# TECHNICAL SERVICE BULLETIN

## 4WD - Grinding/Rubbing Noise Under Acceleration From Floor Pan/Underbody Area

22-2161

<b>Ford</b> 2021-2022 Bronco Sport
2020-2022 Escape
2022 Maverick
<b>Lincoln</b> 2020-2022 Corsair

Figure 1

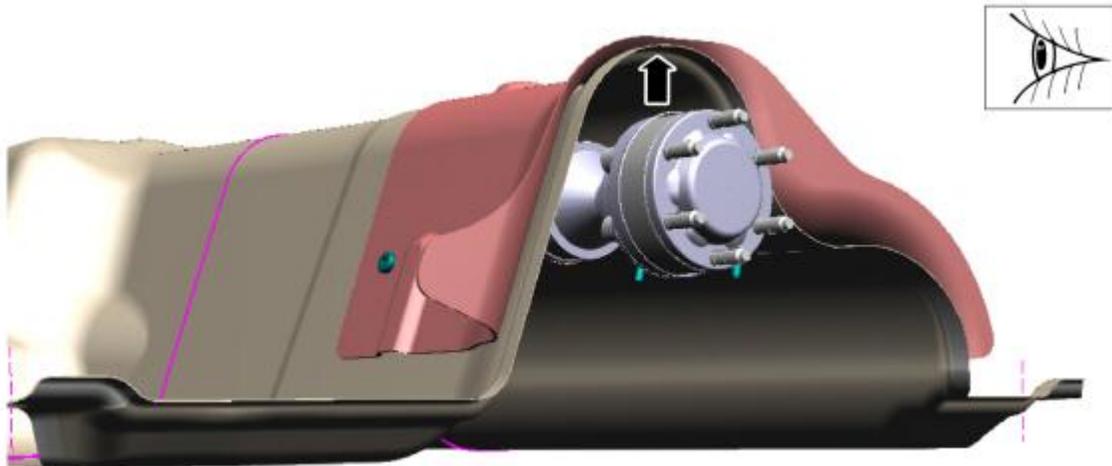
1. Visually inspect the fuel tank heat shield to see if there are witness marks from where the driveshaft has made contact with the fuel tank heat shield.
2. Are there signs of witness marks from the driveshaft contacting the fuel tank heat shield? (Figure 1)
  - (1). Yes - proceed to Step 3.
  - (2). No - this article does not apply. Refer to Workshop Manual (WSM), Section 100-04 for normal diagnostics.

Figure 2

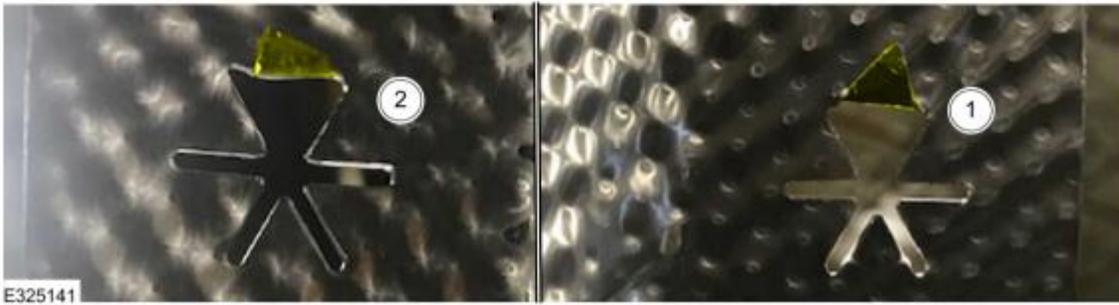
3. Remove the right rear and left front fuel tank heat shield retainer nuts. Refer to WSM, Section 310-01A.
4. Using pliers or equivalent, modify the heat shield attachment star-shaped openings.
  - (1). Bend the tab closest to the front of the vehicle downward and flatten the tab against the bottom of the heat shield. (Figure 2)

**NOTE: Once bent, the tabs should be pointing down and away from the underside of the vehicle. (Figure 2)**
